TWIN TOWERS OFFICE BUILDING
2600 BLAIR STONE ROAD SE
TALLAHASSEE, FLORIDA 32301-8241BOB GRAHAM
GOVERNORVICTORIA J. TSCHINKEL
SECRETARYQUARTERLY REPORT ON GROUND WATER MONITORING
Rule 17-4.245(6)(k)2.

SUMTER COUNTY LANDFILL

SUBJECT: Sumter County Landfill
SC60-132017
Groundwater Monitoring Plan Modifications

SUBJECT: Sumter County Landfill
S060-30674
Groundwater Monitoring Plan

FIG. 19

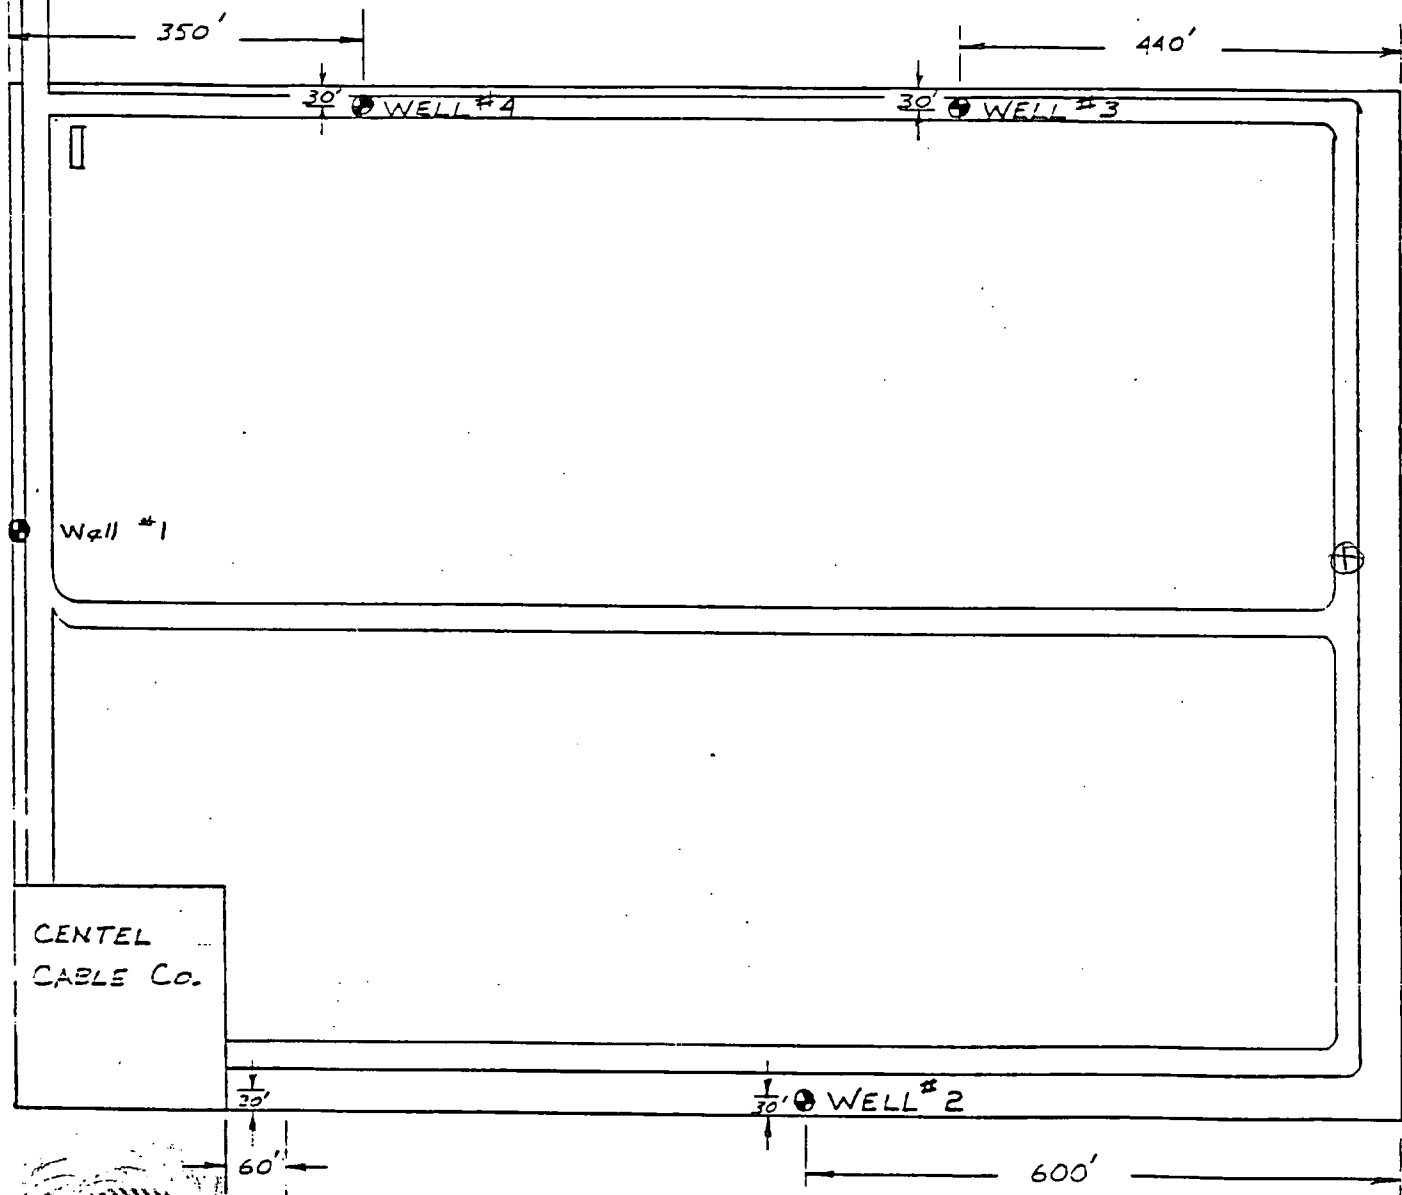
Finally, it was agreed to move MW-1 to the west side of the site, in the middle, and add a fifth shallow monitoring well to the east side. So that there will

Well No. 1 was relocated on the West boundary of the landfill at a point agreed upon by Mr. Putzier and me. The enclosed revised drawing dated January 23, 1985 shows the new location.

FIG. 19
SUMTER COUNTY LANDFILL
PROPOSED MONITORING WELL LOCATIONS

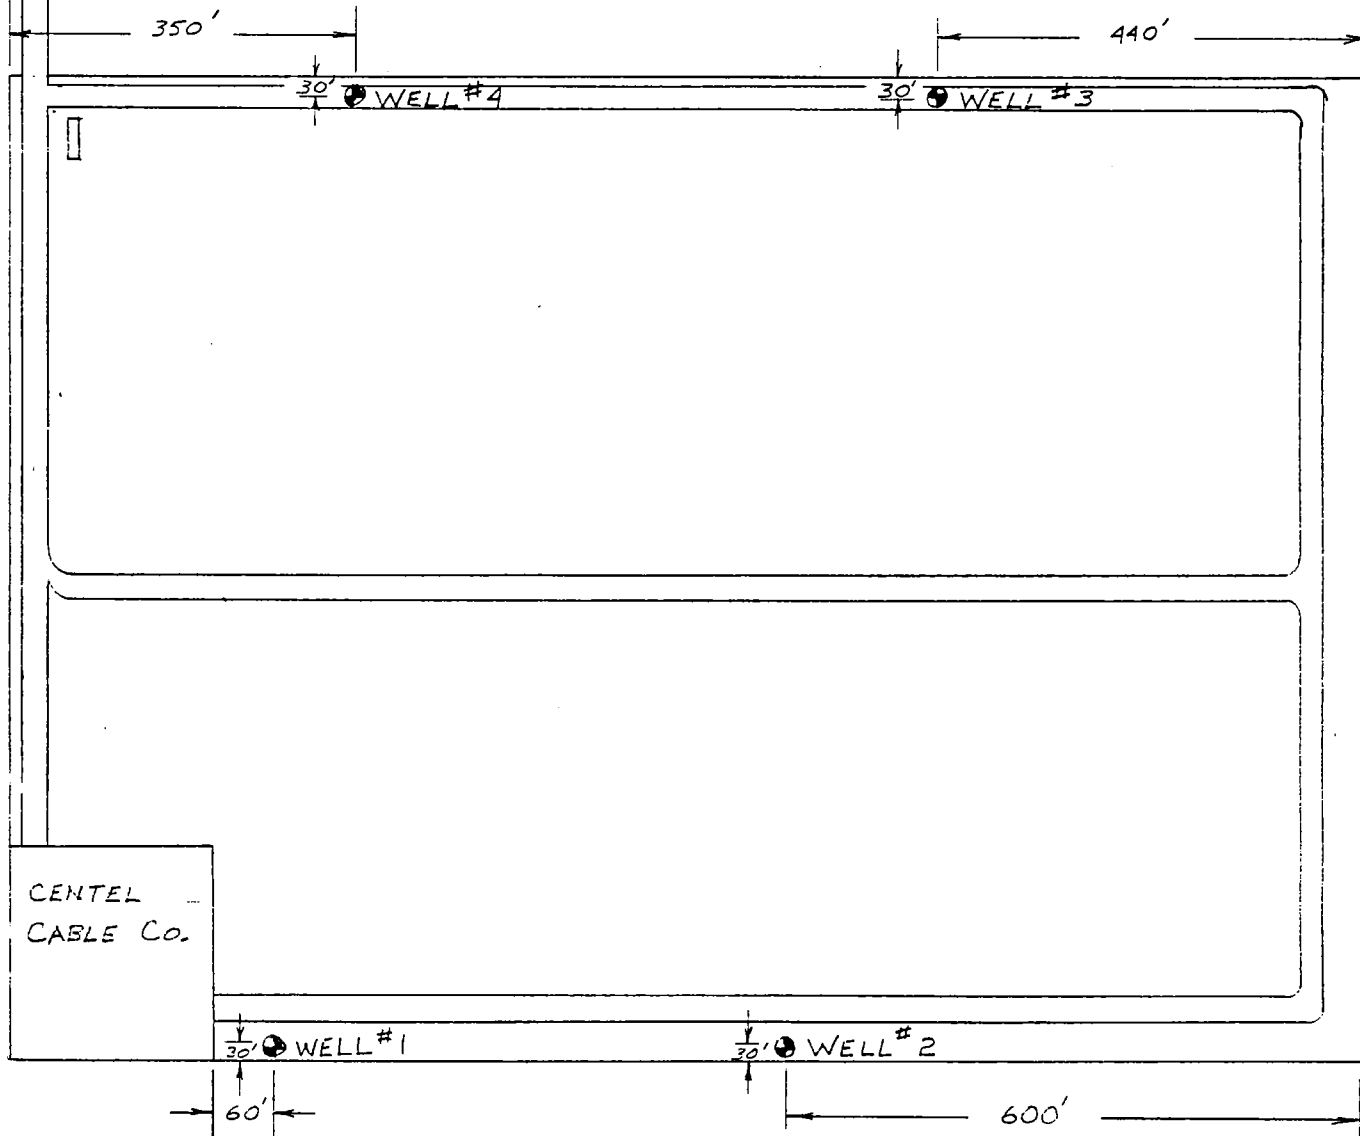
1. The three (3) wells (No. 3, 4, & 6) referenced in your letter are inappropriate for monitoring the landfill. In addition to the four (4) shallow monitoring wells proposed in your monitoring plan, one (1) deep well, constructed in the Floridan, or confined aquifer is required. This well should be located with either of the shallow monitoring wells along the north property line.
2. Screen lengths for all monitoring wells should be a minimum of five to ten feet.
3. A one-time analysis for Primary and Secondary drinking water standards, including volatile organics, is needed for all three (3) downgradient wells.
4. In order to develop a good data base, sampling of monitoring wells should take place on a monthly basis, for at least the first year, for all the parameters listed in your letter of November 9, 1984. Please add water levels and ammonia to that list.

1. The three (3) wells (No. 3, 4, & 6) mentioned in your letter as inappropriate for monitoring the landfill site will be superseded by a single well positioned adjacent to the North property line (See attached figure). This downgradient well will be constructed ten (10) to twenty (20) feet below the encountered upper boundary of the Floridan Aquifer.

MODIFIED GEOLOGICAL CROSS-SECTION A-A

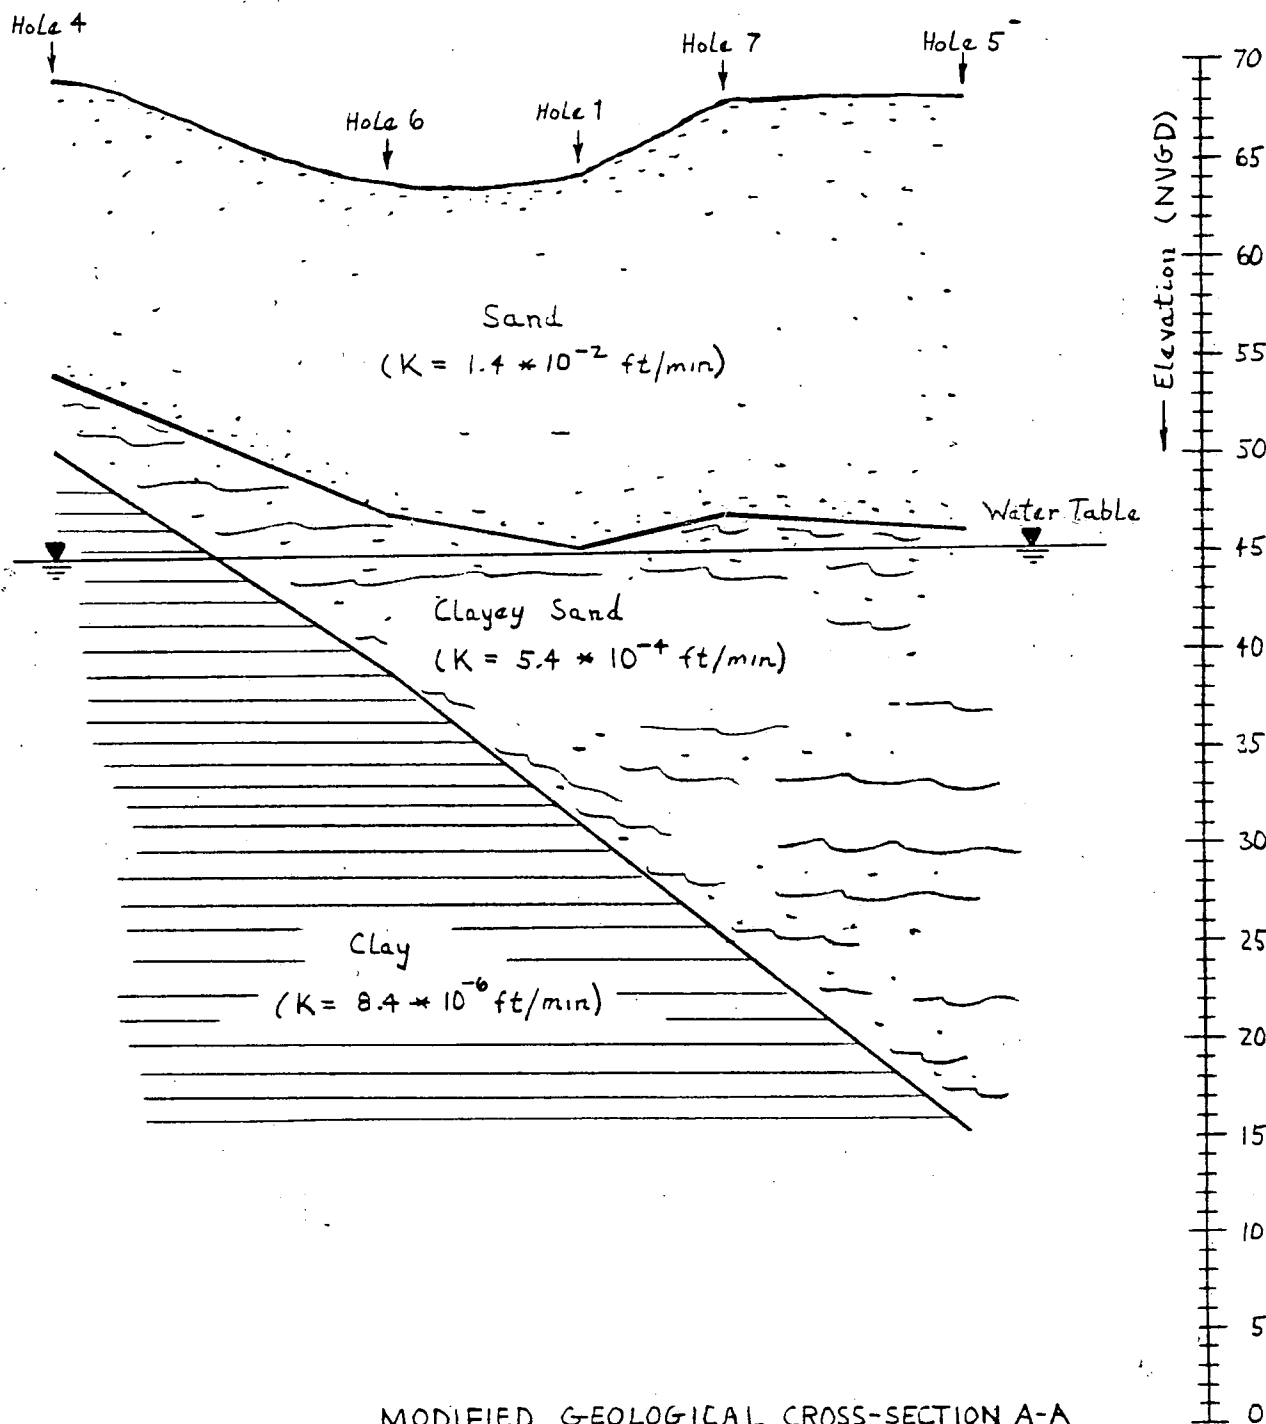
1. The original exploration drillings suggests the underlying clay layer to be discontinuous and an ineffective confining layer above the Floridan aquifer. Additional drillings were taken to provide a better understanding of the nature and extent of this clay strata. Additional boring holes, No. 6 and 7 (See attached figures), at the western boundary of the site revealed the clay layer to be continuous and at least ten (10) feet in thickness. Thus, this clay layer does provide an effective boundary above the Floridan aquifer.
